SCIENTIFIC REVIEW OF FLORA AND FAUNA ASSESSMENT METHODOLOGIES UNDERTAKEN FOR THE FOR THE REPORT "BODANGORA WIND FARM ENVIRONMENTAL ASSESSMENT"

Prepared by Ms Jennifer Smits¹ & Dr George R Wilson¹²

Australian Wildlife Services was consulted to undertake a scientific review of the methodologies and documents relevant to the Flora and Fauna Assessment, part of the Bodangora Wind Farm EA. This included Chapter 9, Attachment G and Attachment H. On review, it was difficult to make an assessment of the likely impact of this wind farm on the flora and fauna present based on the current version of the EA as there was a significant amount of data and mapping missing, including information requested by DGRs and recommended in the *Threatened Species Survey and Assessment: Guidelines for Developments and Activities* (Working Draft) (DEC 2004). A request was placed with the developer Infigen for additional data and maps. These items are outlined below along with summary points on review of the methodologies.

Figure 1. Distribution of the Superb Parrot from Baker-Gabb, D. 2011. National Recovery Plan for the Superb Parrot Polytelis swainsonii. Department of Sustainability and Environment, Melbourne.

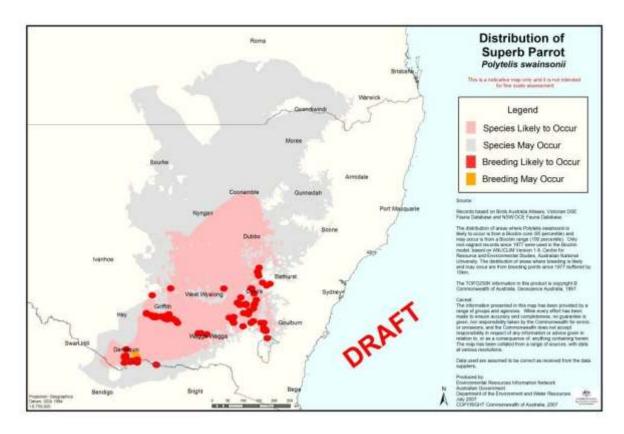
Chapt 9 p 113: Will the results of the superb parrot study pending be available for public viewing and comment before proposed construction? This survey is expected to target woodland on ridges - were woodland areas on ridgelines not surveyed previously in both winter and summer for all bird species, including superbs? Targeted surveys should be required for this species for wintering populations, these are more likely to be impacted than summer populations – as they breed further south (see National Recovery Plan Superb Parrot – 2011 & Figure 1 below).

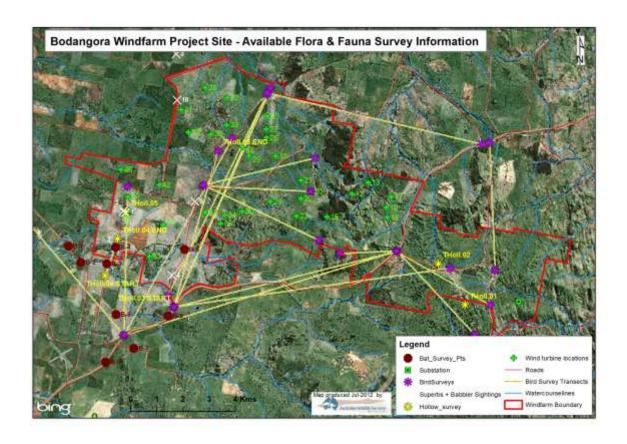
Chapt 9 p106: Grey crown babbler was observed at one site. However there is no indication of site stratification that targeted this species.

• How many similar sites did they assess for this species?

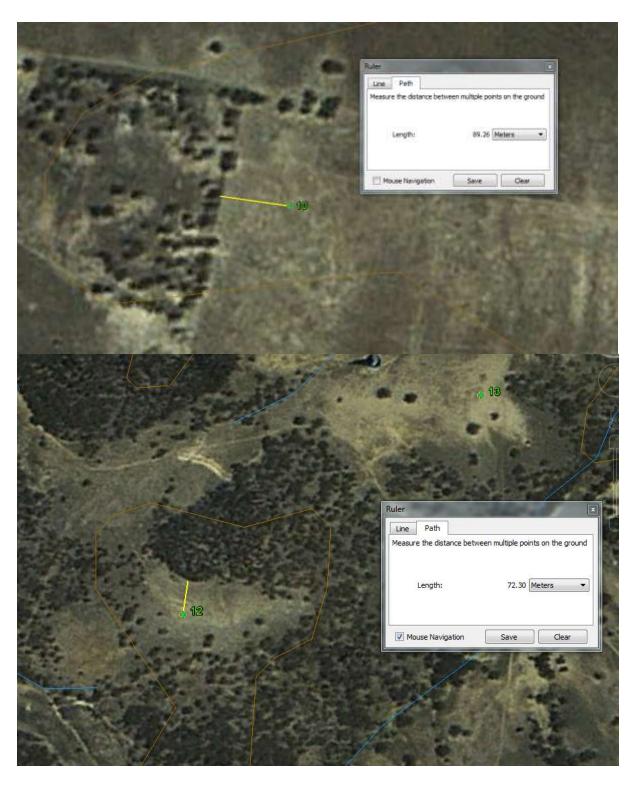
But conversely to the statement quoted above "each of the proposed wind turbine tower locations was visited", Appendix 4 states that turbines 9-16 were not visited and declared 'cleared paddock'¹. Inspection of Google Earth at each of these sites shows clearly trees within 50-200 m of each location (see example WTG 10; WTGs 12 & 13).

Source: Eco Logical Australia, (2008). Editing Mitchell Landscapes, Final Report. A Report prepared for the Department of Environment and Climate Change.

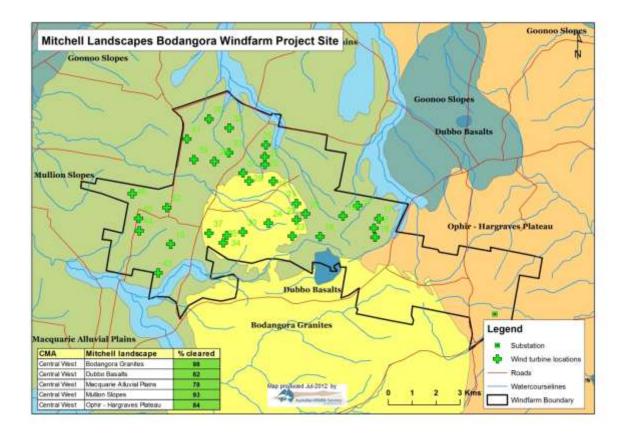
While the proponents are not required to satisfy legislation enacted by the *Native Vegetation Act* 2003 as the development is being assessed under Part 3A of the EP&A Act, consideration should be given to the Mitchell landscape types affected within the project area. Such highly cleared areas are likely to be in an environmentally or functionally fragile state – where small pockets and remnant of vegetation are important to continue to connect the landscape and habitats. While these landscapes could be better managed to encourage regrowth of healthy systems through grazing management and revegetation, emphasis needs to be put on the importance of retaining remnant vegetation in these areas. The Mitchell Landscapes present in the area are shown in the table below. All landscape types have been highly cleared 78-98%, where it is recommended that no clearing occurs in ecosystems that are more than 70% cleared and not in low condition (Native Vegetation Act 2003).
